UNITED STATES PATENT AND TRADEMARK OFFICE

APPLICATION NO.	FILING DATE	FIRST NAMED INVENTOR	ATTORNEY DOCKET NO.	CONFIRMATION NO.
10/712,070	11/13/2003	Kotaro Kashiya	80329-0016	7914

Office Action Summary

DETAILED ACTION

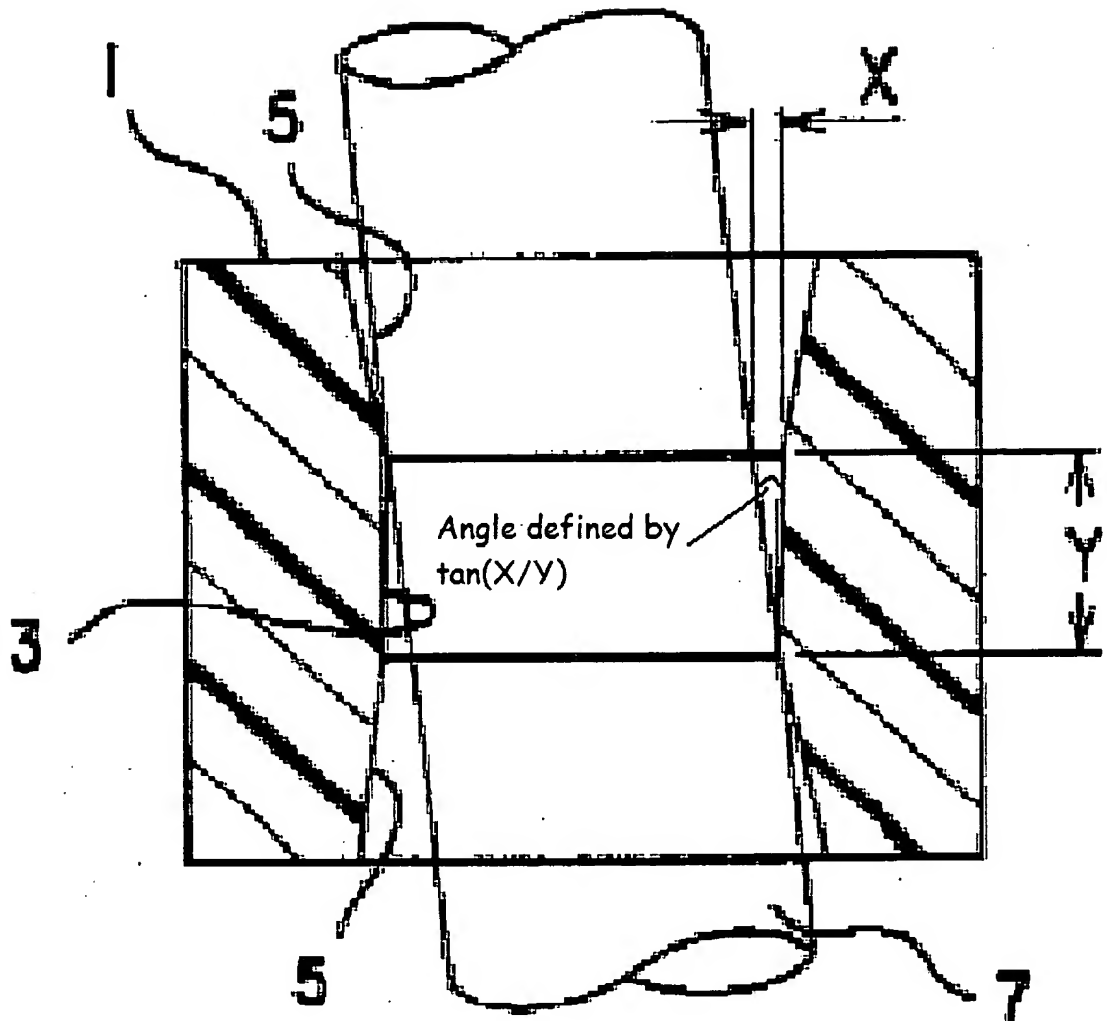
Regarding claim 3, Okada defines a clearance X, between the shaft and sliding surface (Y) and X/Y is greater than or equal to 0.052, where $\tan(X/Y)$ defines an angle between the central axis of the bearing and the angle of the shaft (see fig below).

At a minimum (i.e. $X/Y=.052$), the inverse tangent of X/Y is 2.97 degrees which defines the minimum possible angle of the second and third surfaces and satisfies the limitation that the angle must be between 0.05 and 5 degrees.
